Date: October 21, 2003

To: T10 Technical Committee

From: Keith Holt (LSI Logic)

Subject: End-to-End Data Protection Interoperability

Figure 1 – Interoperability Model for System with mix of E2E Capable and Legacy Hosts

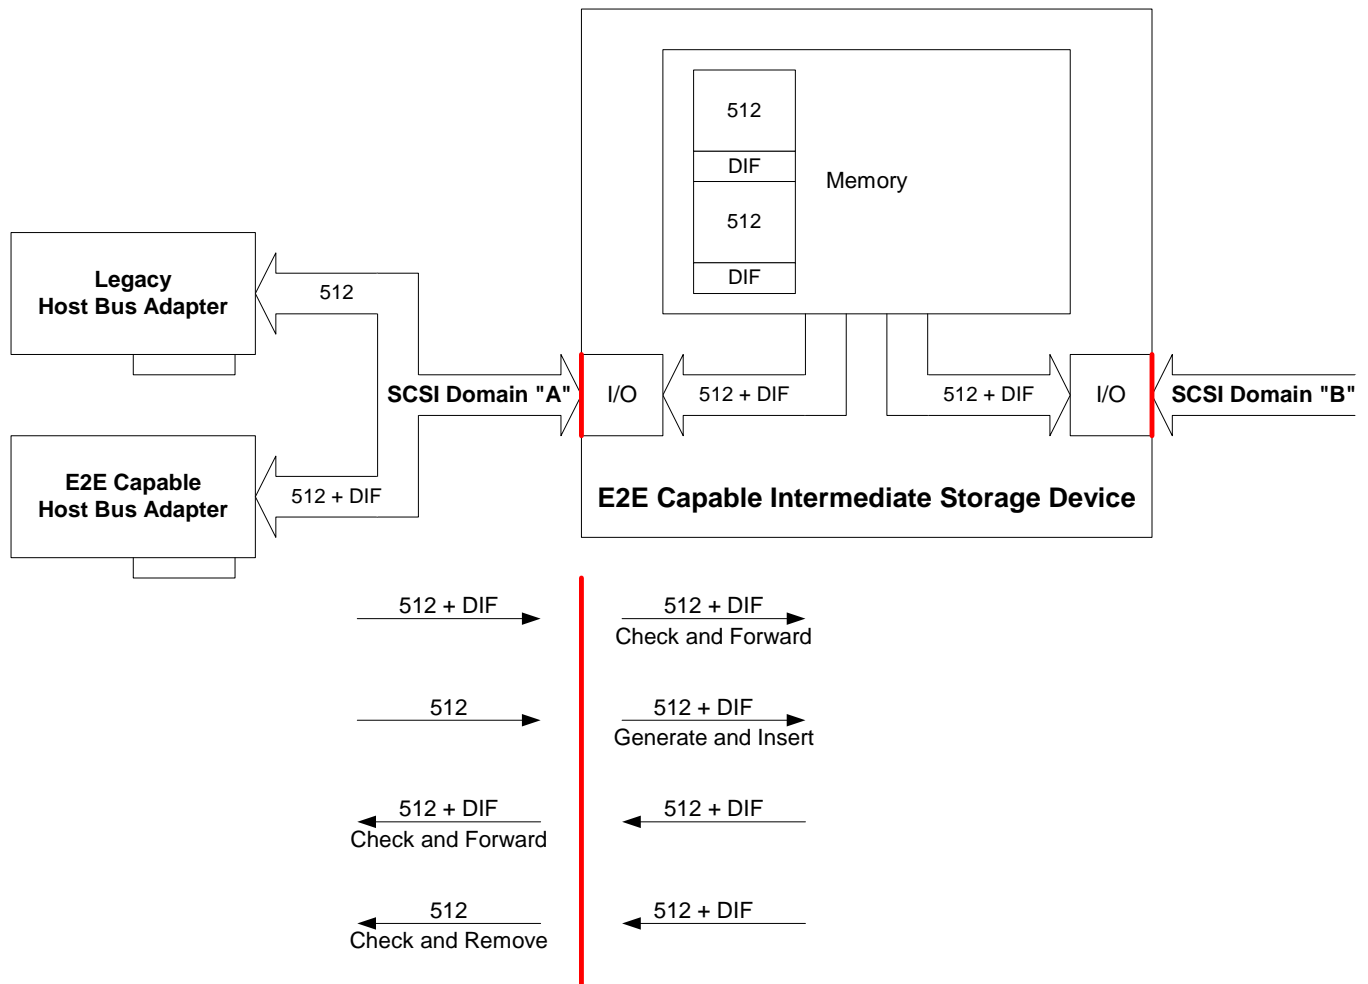
The system example in Figure 1 shows a system with a mix of E2E capable and legacy hosts. In this example, all logical units in SCSI domain A are assumed to be formatted with E2E protection. If both host systems wish to access a common set of logical units in SCSI domain A, the device server has two basic choices on how to handle legacy writes:

If the device server is an intermediate device as shown in the system example in Figure 1, it is desirable to write a default pattern using the same algorithms as the E2E capable hosts. This provides E2E protection on the internal data paths of the intermediate device. In addition, this protection can be extended to the second SCSI domain, B, which the storage media resides. If the E2E capable application client uses LBA-locked REFERENCE TAGS, the device server can ensure interoperability with legacy hosts by inserting valid protection information with LBA-locked REFERENCE TAGS into the data stream received from legacy hosts. This model requires that the APP_TAG_OWN bit be set to zero for the logical unit, assigning ownership of the APPLICATION TAG to the device server.
